Before the Hearing Panel

Under	the Resource Management Act 1991 (the Act)
In the matter of	Proposed Plan Change 1 to the Natural Resources Plan for the Wellington Region Hearing Stream Three - Rural land use activities, Forestry including vegetation clearance and Earthworks
Between	Greater Wellington Regional Council Local authority
And	Transpower New Zealand Limited Submitter 177 and Further Submitter FS020

Statement of evidence of Pauline Mary Whitney for Transpower New Zealand Limited

Dated 5 May 2025

Figure 1. Image showing areas of "Highest erosion risk land (Woody vegetation)" (shown in lime green squares)

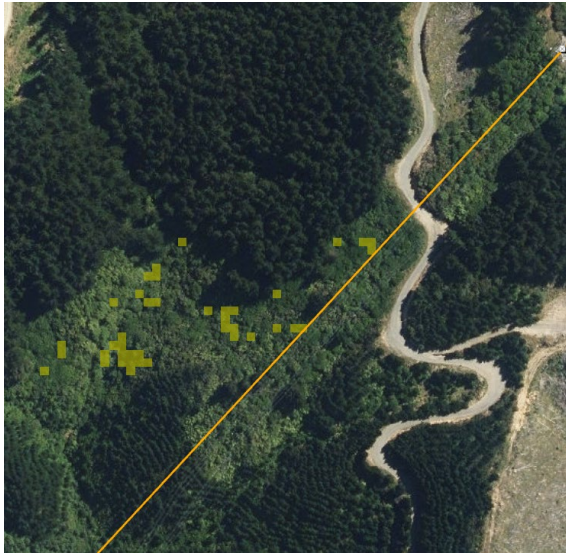
- 9.14. In its submission Transpower was neutral on the definition of Highest Erosion Risk Land¹⁵ but in submission point S177.084 and S177.085, sought the maps (91 and 94) be amended to only identify cohesive areas of vegetation being subject to the rules. The mapping includes numerous small and incohesive areas of vegetation, and I question the efficiency or effectiveness of regulating numerous small (which in many cases measure no greater than 5m by 5m) incohesive areas of vegetation. Rules WH.R18 and P.R17 imposes a minimum threshold for the removal vegetation on highest erosion risk land of 200m² with the resolution of mapping being produced at a much finer level (5m by 5m). It would assist plan administration if the mapping of woody vegetation was undertaken at a level that aligns with the rules i.e. in 200m² blocks.

- 9.15. As identified in the image below, there are parts of the National Grid that are located over or near land that is mapped as “Highest erosion risk land (Woody vegetation)” in Map 91. In its submission Transpower seeks amendments to the permitted activity rules for vegetation clearance on highest erosion risk land (woody vegetation) to ensure that vegetation clearance less than 200m² is clearly provided for under the rule (and is not an innominate discretionary activity), and that an exclusion be provided for the National Grid.

<i>Planning Maps 91 and 94</i>	Amend ²⁴ Maps 91 and 94, and the associated GIS map layer, to only identify cohesive areas of “Highest erosion risk land (Woody vegetation)”.	<p>The s42A Report agrees with submissions that suggest the identification of highest erosion risk land and the supporting mapping is problematic. The s42A Report recommends the amended maps now be used as a guide to help land management and landowners identify areas of a farm which require further assessment of the need for erosion treatment as part of the farm plan development process</p> <p>The s42A Report supports the NRP definition of erosion prone land be reinstated in PC1. The recommended amendments mean these rules will apply to land which meets the NRP definition of erosion prone land rather than the PC1 highest erosion risk (woody vegetation) mapping.</p>	Delete individual maps and combine into two maps 90 and 93 “Potential erosion risk land”.	<p>On the basis of the recommended amended rule framework, the recommendation to delete and replace the maps is supported.</p> <p>It is noted the reference to “potential erosion risk land” does not apply to any plan provisions that would apply to the National Grid.</p>
